COMMUNITY ZONING INFORMATION MEETING

Agenda Item	Text Amendment
RZ23-01	Article XIX Crabapple Form Based Code as it relates to possible amendments related to the District at Mayfield and other related topics of the Crabappale Form Based Code.

AN ORDINANCE TO AMEND ARTICLE XIX CRABAPPLE FORM BASED CODE, (CHAPTER 64 OF THE CITY CODE) TO ESTABLISH THE DISTRICT AT MAYFIELD AND TO AMEND THE CRABAPPLE REGULATING PLAN

RZ23-01 - Text Amendments Adopting the District at Mayfield prepared for the Mayor and City Council Meeting on June 5, 2023

Table 4: Civic Space

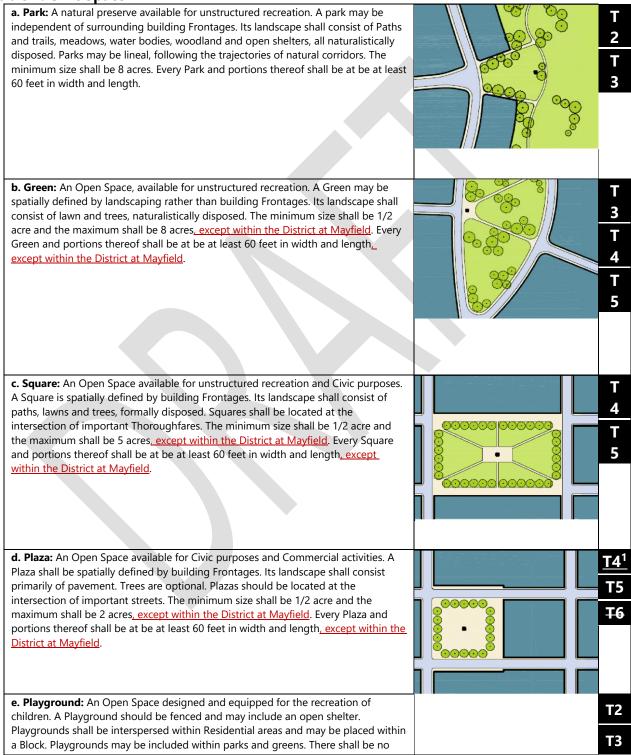
minimum or maximum area, except that every Playground shall be at least 60 feet in width and length, except within the District at Mayfield.

f. Pocket Park: An Open Space available for passive recreation and relaxation. Pocket Parks shall include seating, trees, and other landscaping. Pocket Parks shall be interspersed within Residential areas. There shall be no minimum or maximum area, except that every Pocket Park shall be at least 60 feet in width and length_except within the District at Mayfield.

Table 5: Building Form - Height.

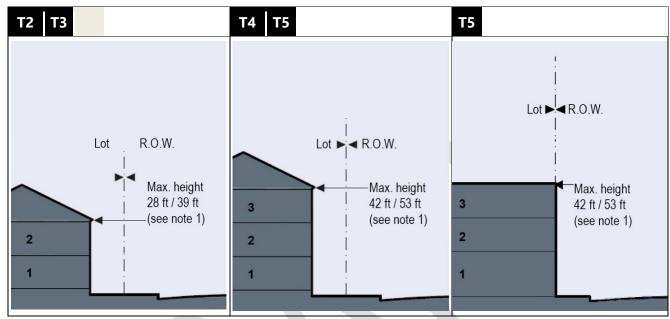
This table shows the configurations for different building heights for each Transect Zone, except within the District at Mayfield Section 4.5.1.L shall apply.

Table 6: Building Placement

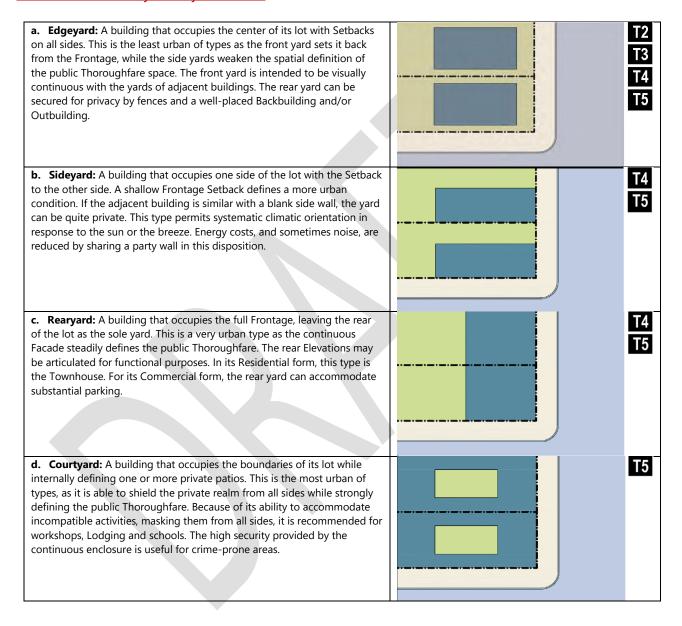
This table approximates the location of the structure relative to the boundaries of each individual Lot, establishing suitable basic building types for each Transect Zone, except as further restricted by in the District at Mayfield by Sec. 4.4.4.

Table 10: Code Summary

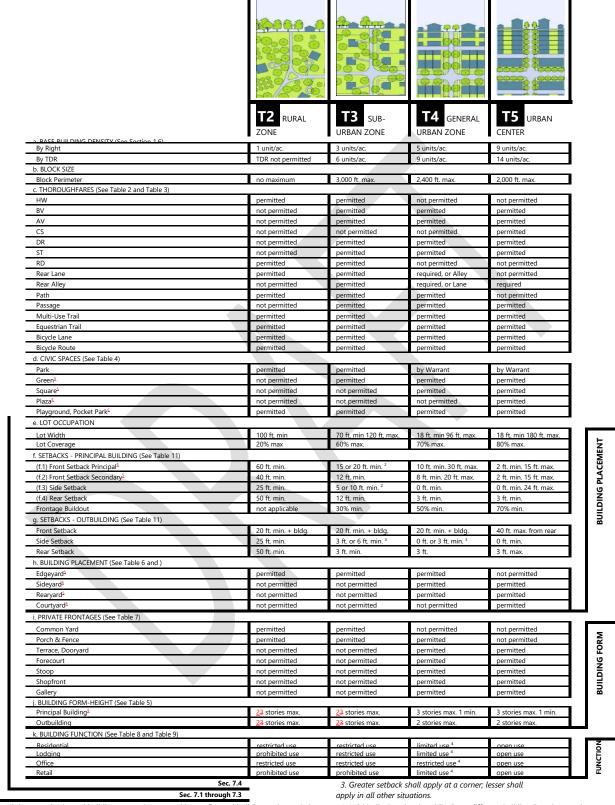
^{4.} Within T4-Restricted and T4-Open different Building Function requirements 5. Within the District at Mayfield different requirements apply.
